## **ADDENDUM NO. 2**

**Project:** CITY OF GREAT FALLS INDOOR AQUATICS AND RECREATION CENTER  
**Project No.:** 20-019  
**Date:** OCTOBER 1, 2021  
**Bid Date:** OCTOBER 13, 2021

DESIGNED BY:	RLT
CHECKED BY:	SWM
DATE:	08/06/2021
PROJECT NUMBER:	20-019
SHEET NUMBER:	<b>S7.2</b>

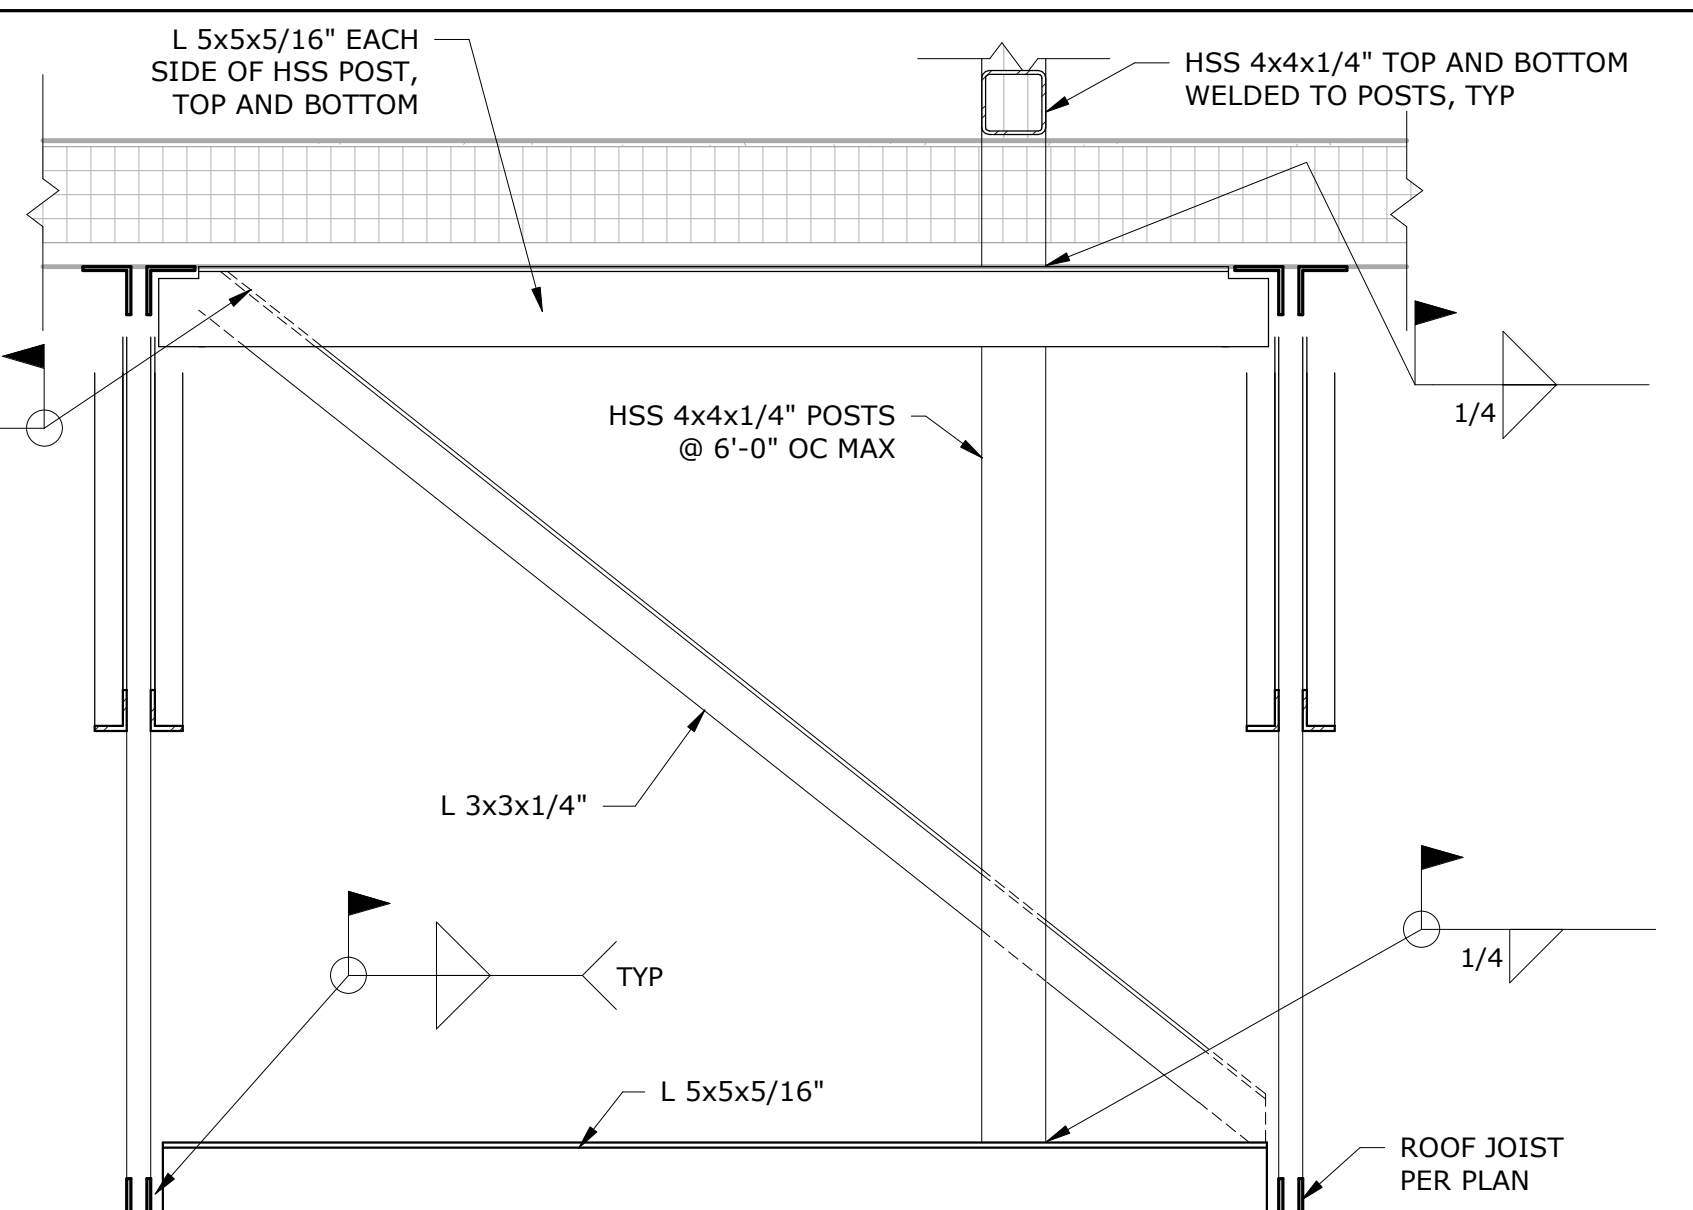
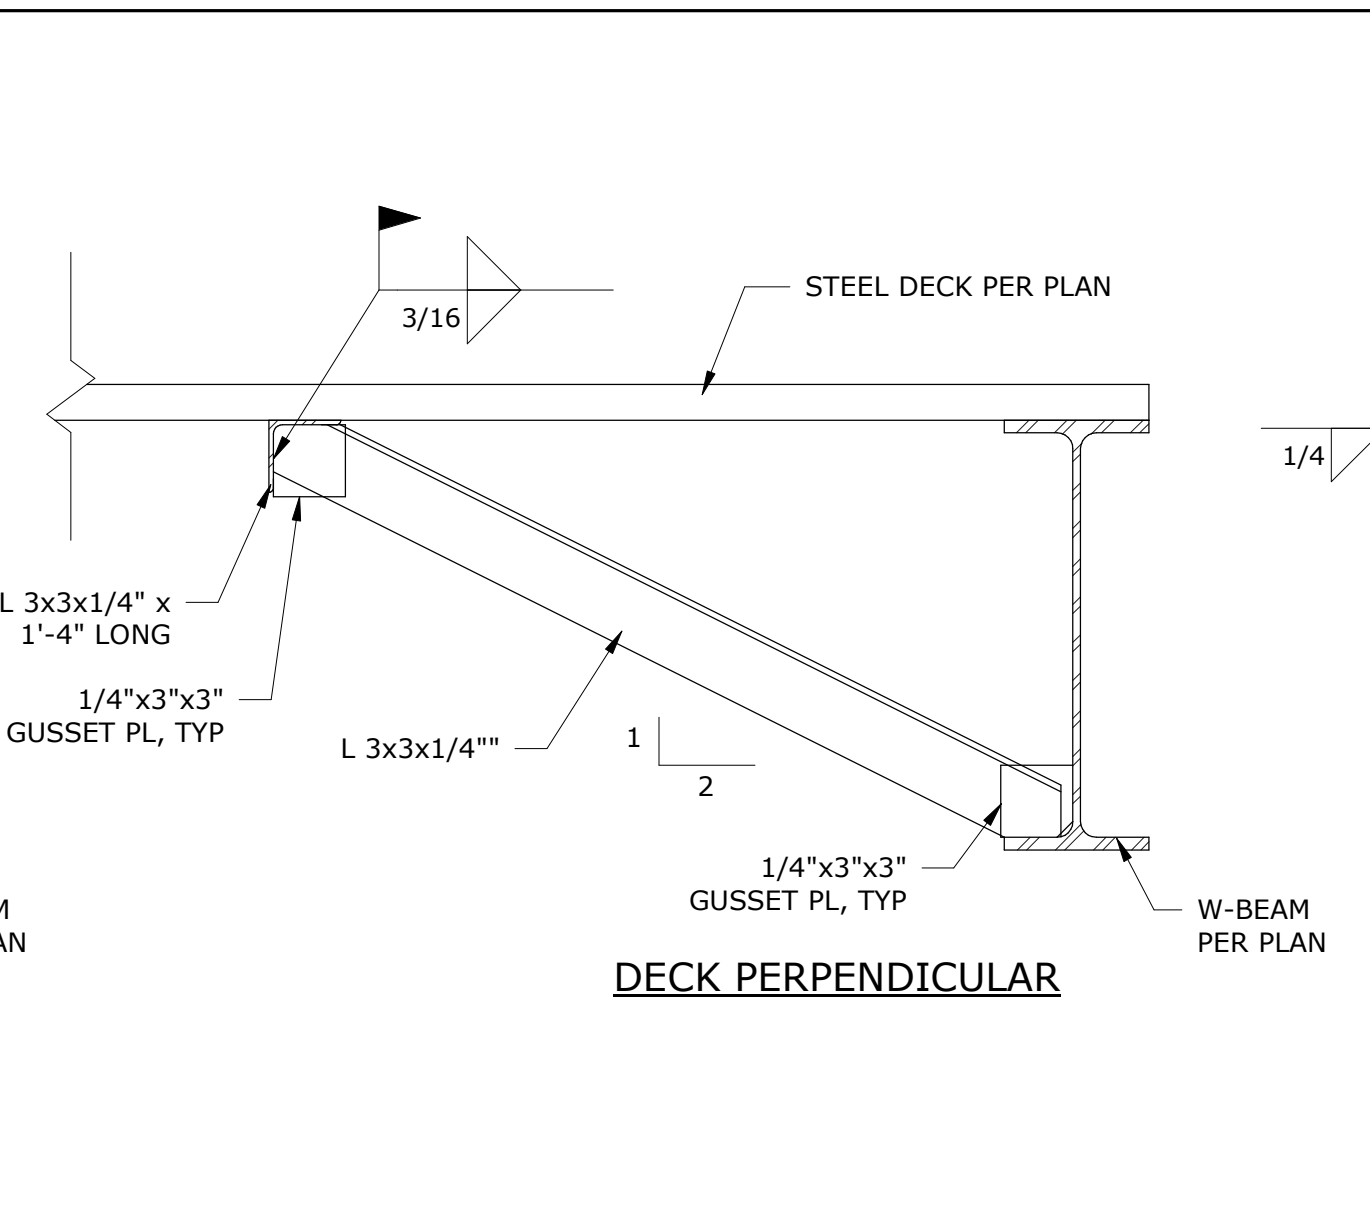
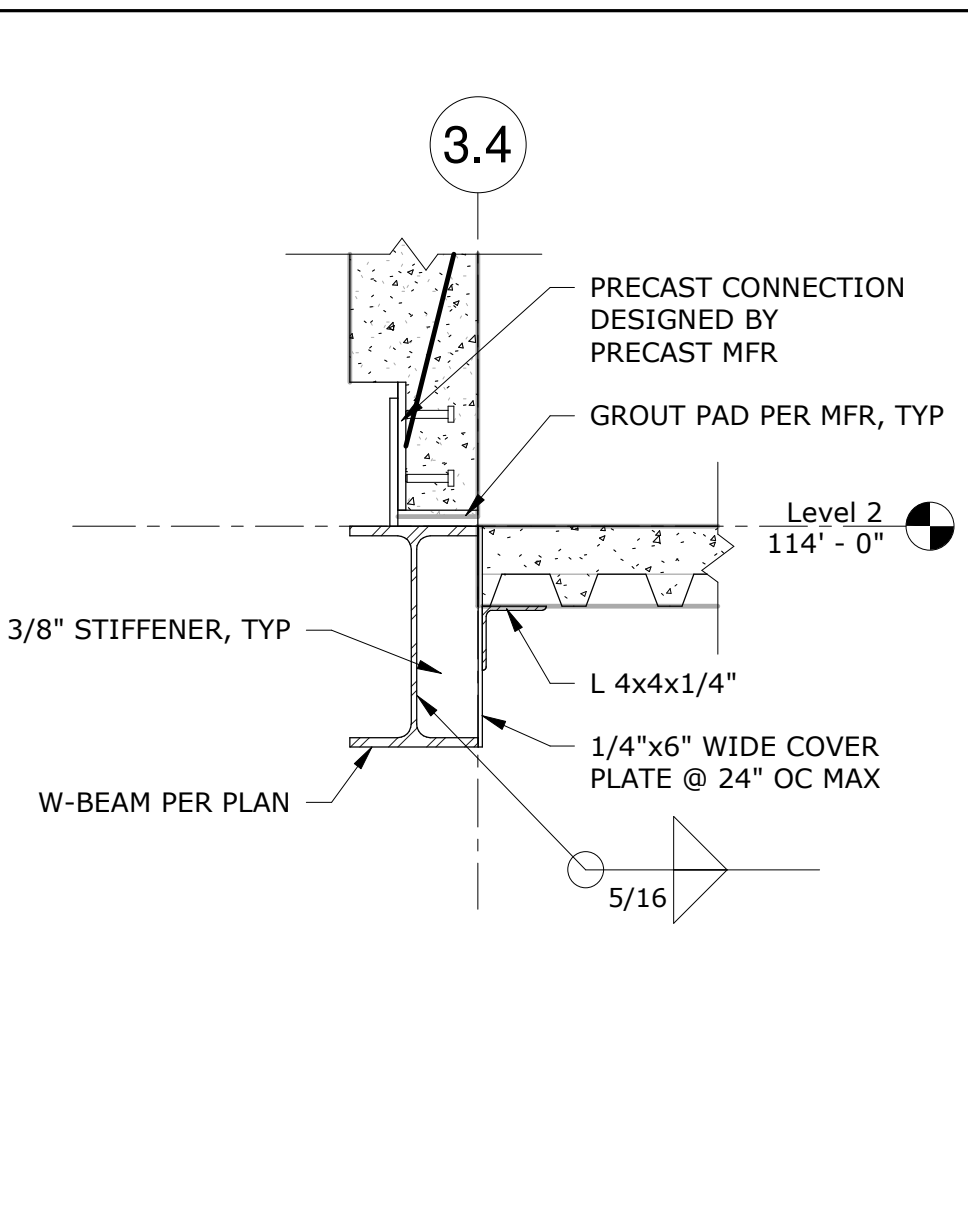
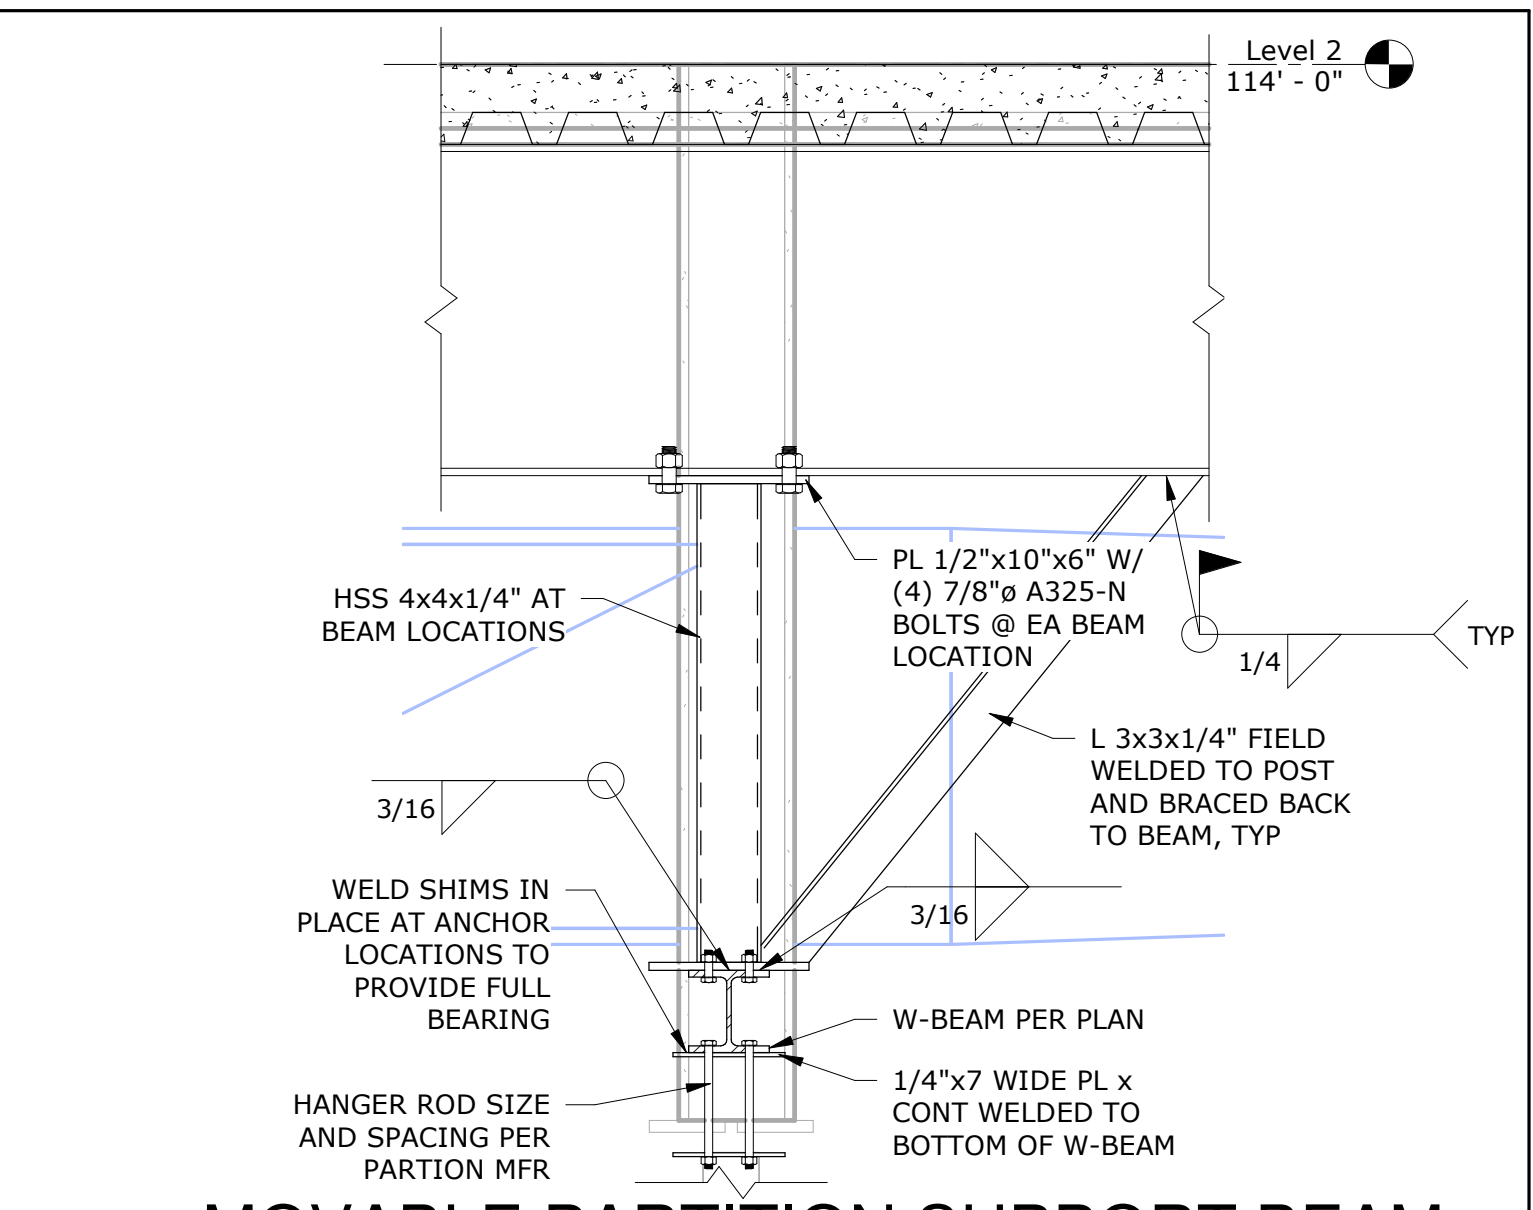
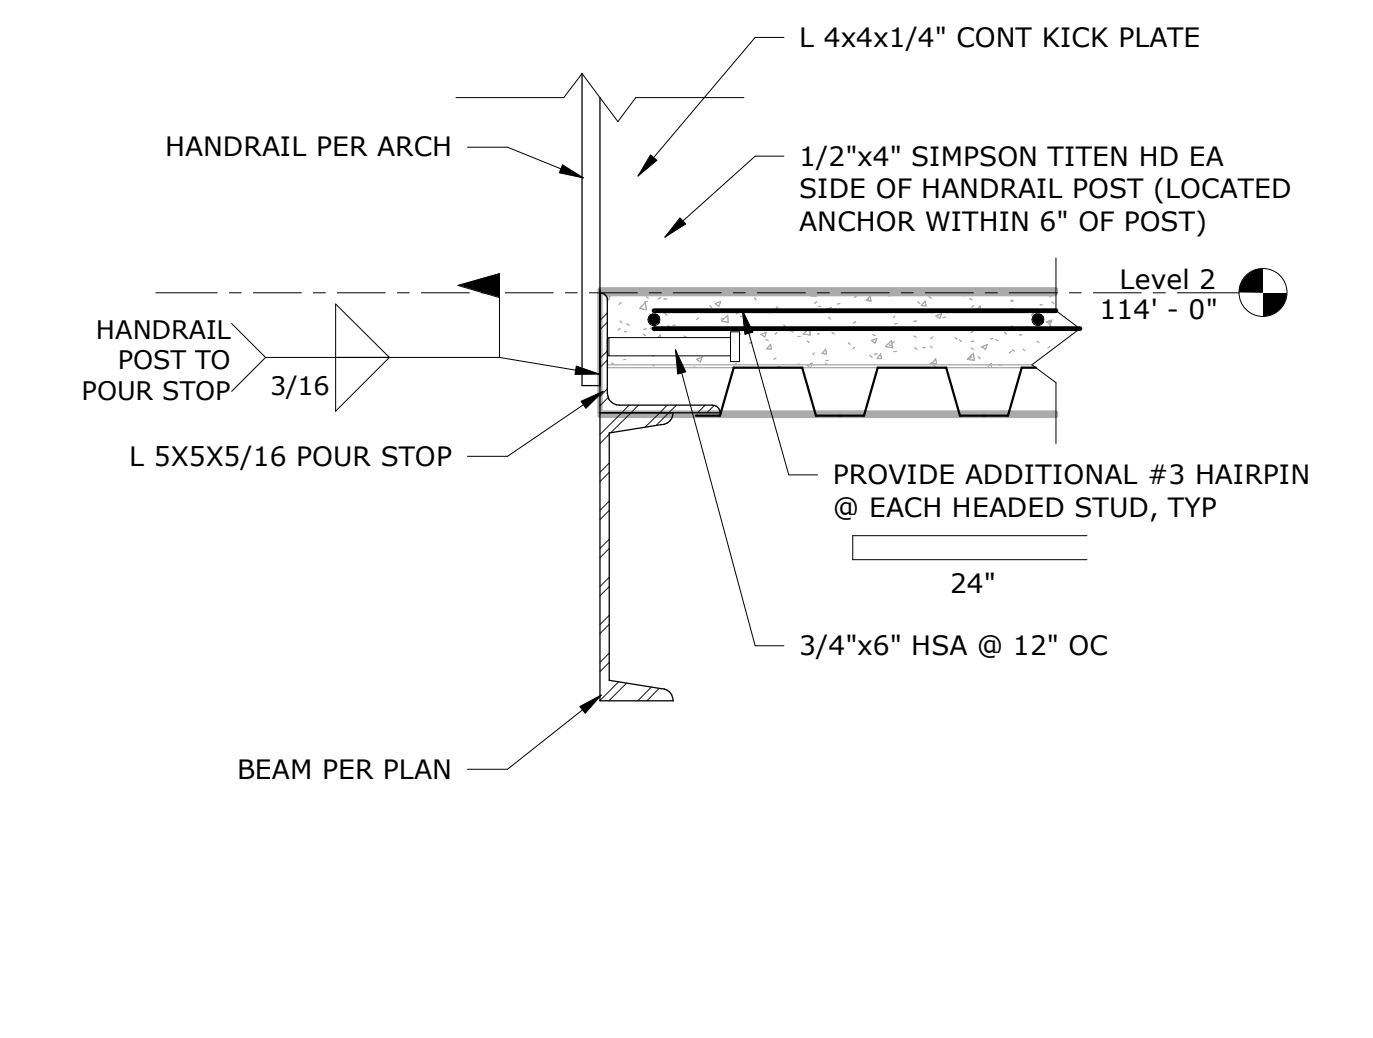
- ITEM NO. 22 **CHANGE:** (4) Structural Sheets updated (See Attachment "E")  
S3.0: Provided slab slope clarification and shifted a footing.  
S4.0: Added 1-special joist callout  
S7.2: Adjusted 3-joist details  
S8.0: Adjusted several joist loading diagrams and added a clarification note.
